ITEM NO 3
MEETING DATE January 7th, 2016
STAFF Clay Frickey

STAFF REPORT

PROJECT: College Eight Thirty, PDP150019

RECOMMENDATION: Staff recommends approval, with conditions, of College Eight Thirty, PDP150019.

A OVERALL SITE PLAN

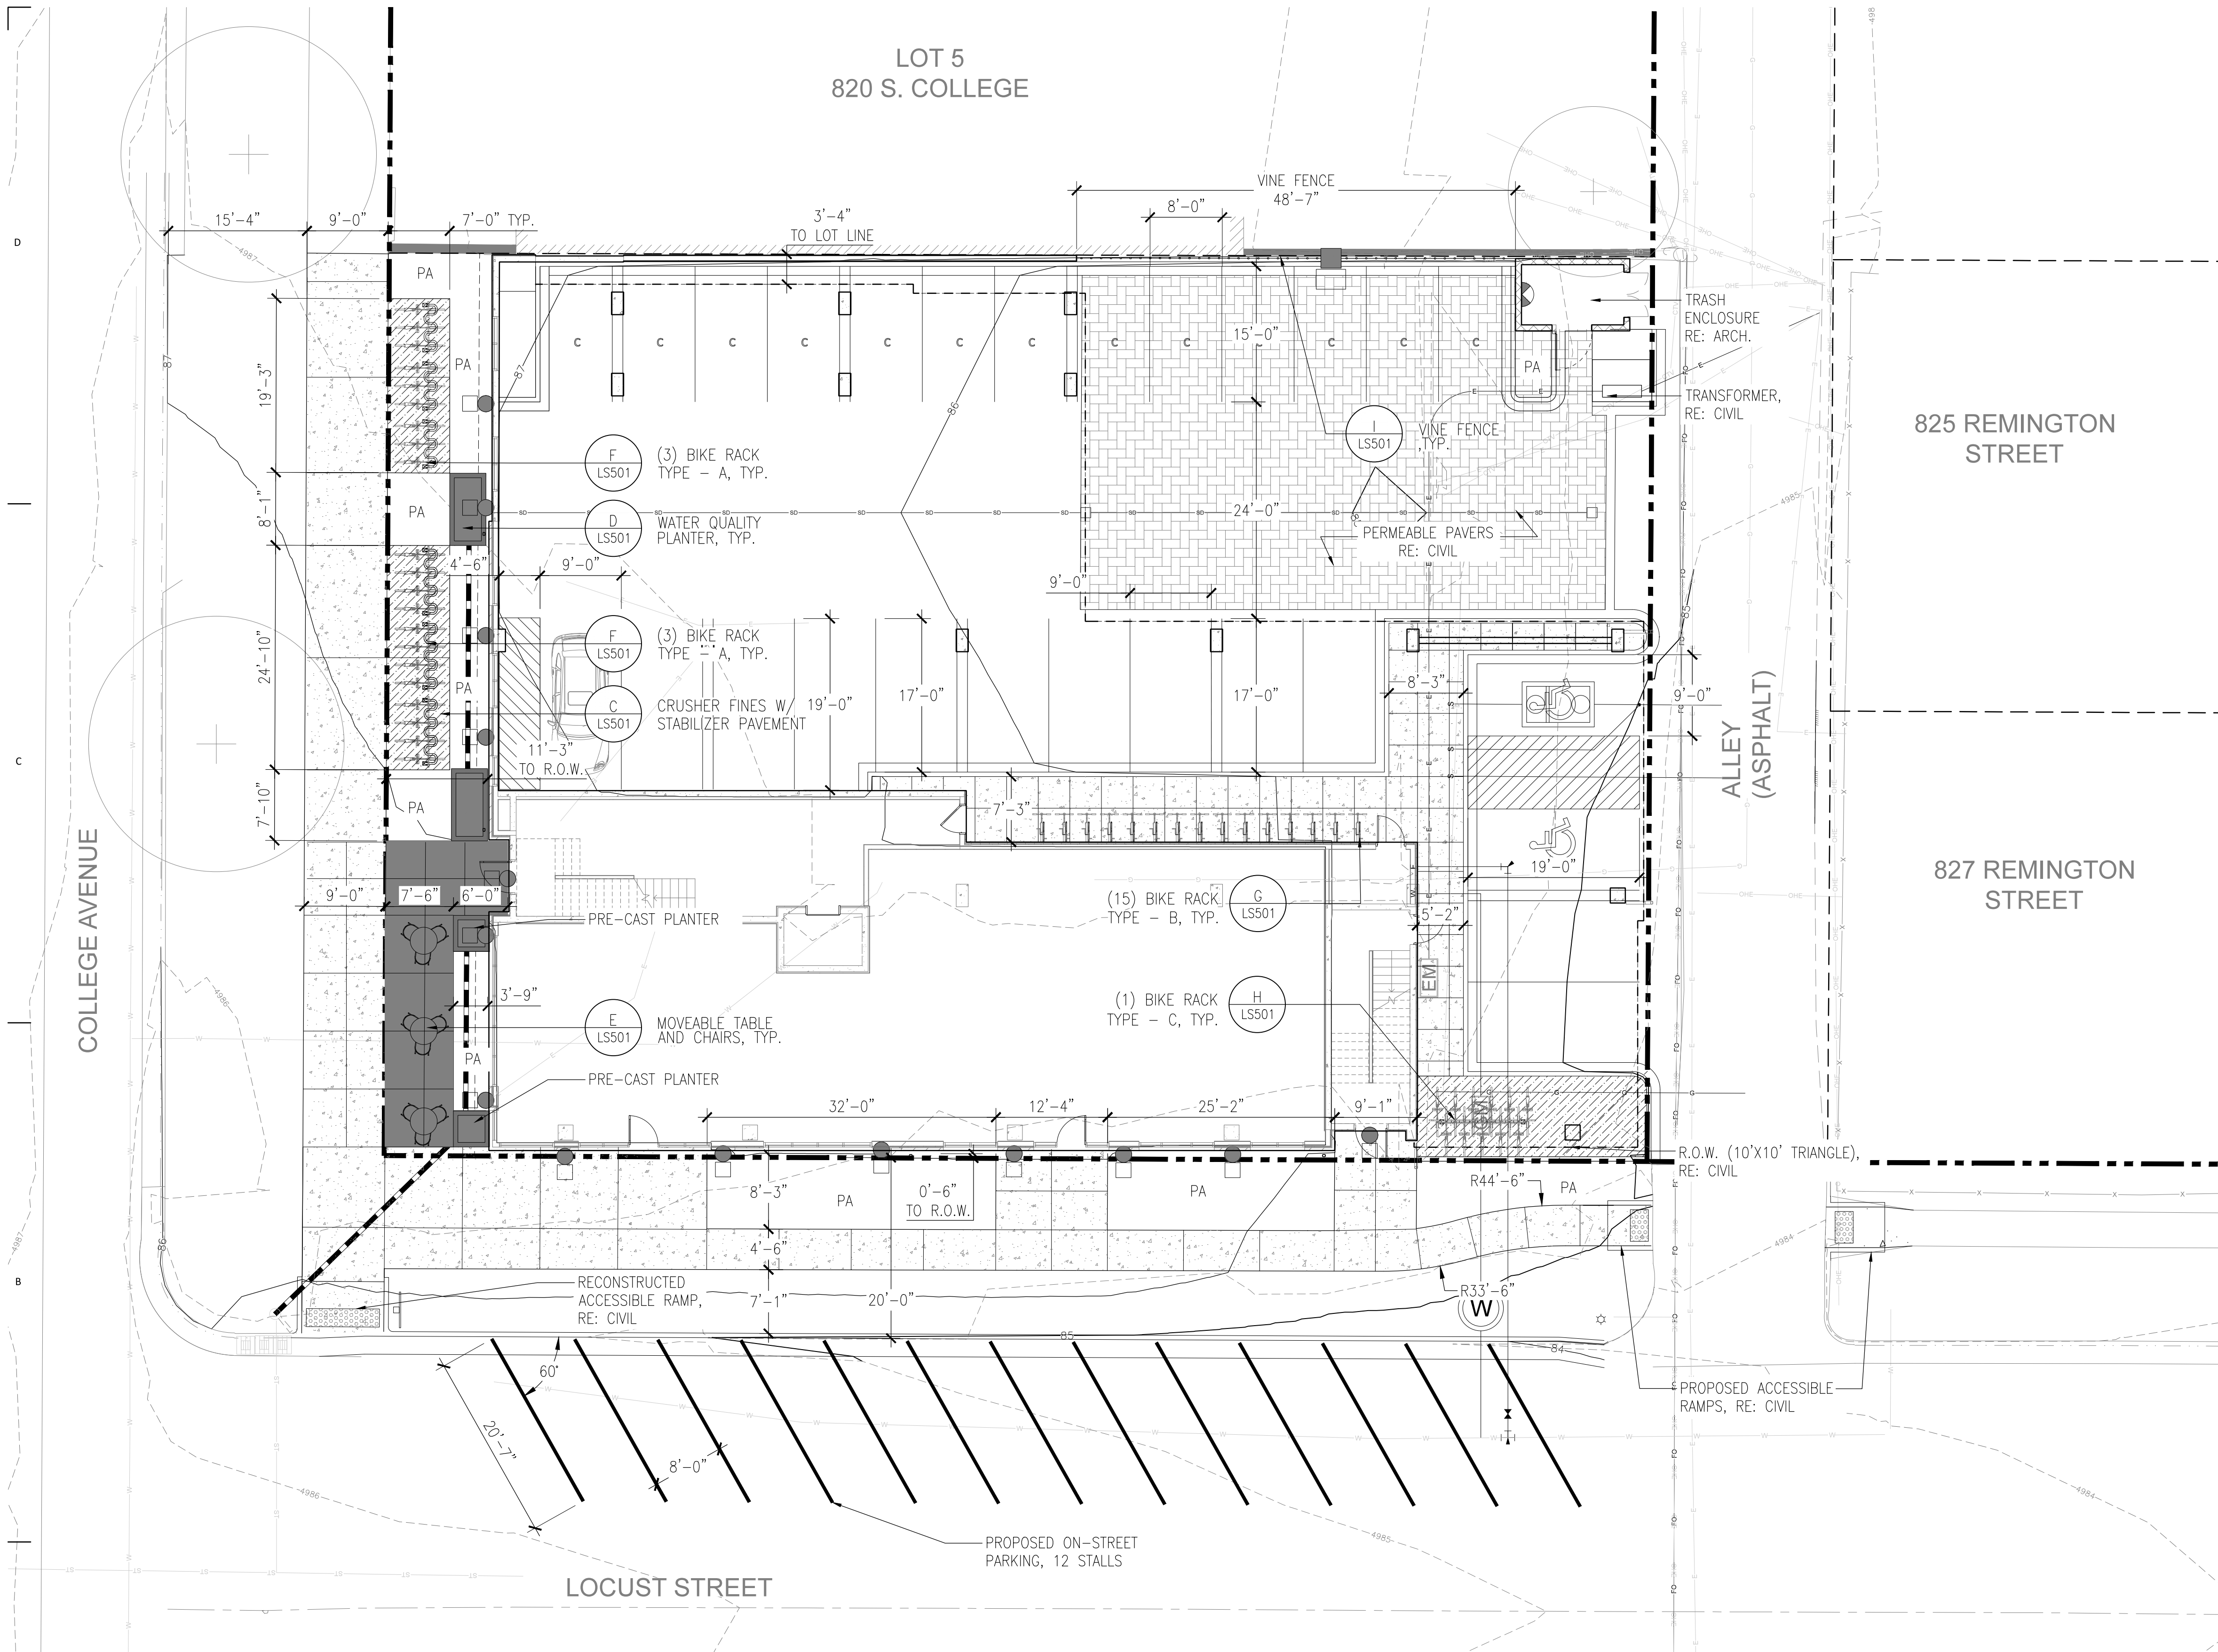
All of the compact spaces are located on the northernmost section of the parking area. By providing compact stalls for the entire north side of the parking lot, the parking area retains a 24 foot-wide drive aisle. A 24 foot-wide drive aisle ensures cars can safely pass one another and maneuver in the parking area. 24 feet is also the minimum two-way drive aisle width allowed per Land Use Code Section 3.2.2(L). By meeting the minimum parking stall dimensions outlined in the Land Use Code (9' wide by 19' deep) the drive aisle would only be 20 feet wide, which would require a modification. Staff would not support a modification to the drive aisle width since a 20' wide drive aisle would create safety issues that could not be mitigated. Staff would also not support a modification to the drive aisle width

Exceeding the maximum number of allowed compact parking stalls also allows the developer to provide additional parking spaces. The length of the proposed parking area on the north edge of the property is 108'-6". The maximum number of standard parking stalls that could fit in 108'-6" is 12 spaces. The site plan shows three structural supports in the site plan that take up a total of 7'-6" feet in width, which means the available width for parking stalls is actually 101'. This means only 11 standard parking stalls could fit within that area of the parking lot. A net loss of two parking spaces would mean that the development would not meet the minimum parking required while taking advantage of two parking exemptions (transit passes for each resident and existing building exemption for the commercial parking requirement). Staff would not support a modification request to the overall number of parking spaces required since the development will already be allowed the aforementioned exemptions to reduce their minimum parking required.

The site plan shows 27 parking spaces to serve the proposed development. Based on the standards for multi-family developments in the Transit Oriented Development Overlay Zone and commercial parking requirements, the minimum amount of parking for this development is 35 spaces.

Parking lots with 26-50 parking spaces are required to provide two handicap parking spaces. The site plan shows two handicap parking spaces alongside the alley, which is in close proximity to entrances on the north, south, and east sides of the building.

Staff concludes that the modification request is justified as the requested increase to the amount of compact parking stalls is inconsequential in the context of the overall development plan. This modification also allows the development to better meet other Land Use Code standards for drive aisle width and overall number of parking spaces.
